Midway City Council
19 July 2022
Regular Meeting

Watts Remund Farms, Phase 4 /
Final Approval

CITY COUNCIL MEETING STAFF REPORT

Subject: Remund Farms – Phase 4 Preliminary Review

Midway Springs Wetland Delineation Map

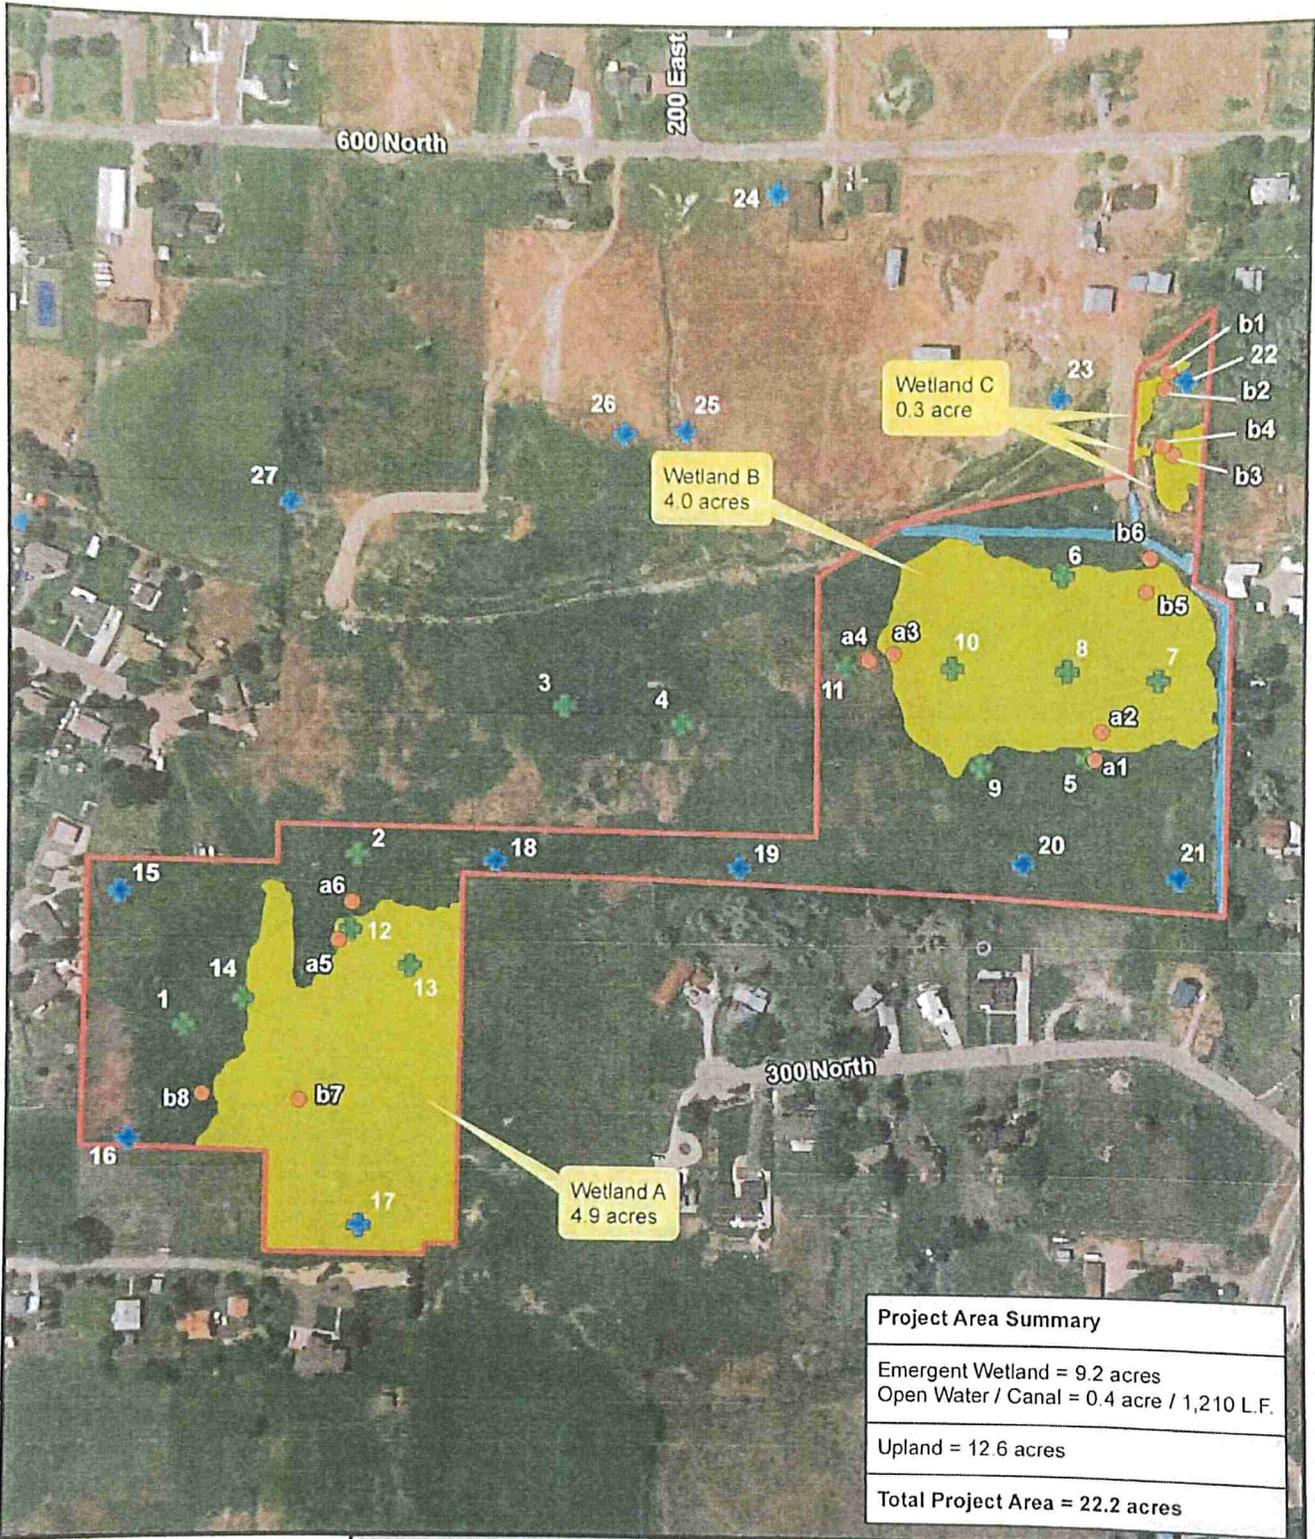
Please find attached the revised wetland delineation map of the 22.2-acre Midway Springs Project Area in Midway, UT. The revised map reflects the changes to Wetland Area B that we discussed in the field during our site visit to verify the wetland boundaries on May 31, 2018. Specifically; the eastern boundary of Wetland Area B was modified to illustrate two existing connections to the eastern open water/canal feature shown on the map. This change did not result in any significant change to the wetland acreage which remains at 4.0-acres for Wetland Area B, and 9.2-acres for the overall project area. The modified wetland map also now shows the location of all of the existing groundwater monitoring wells on the project area, and surrounding the project area, including those installed in March 2018.
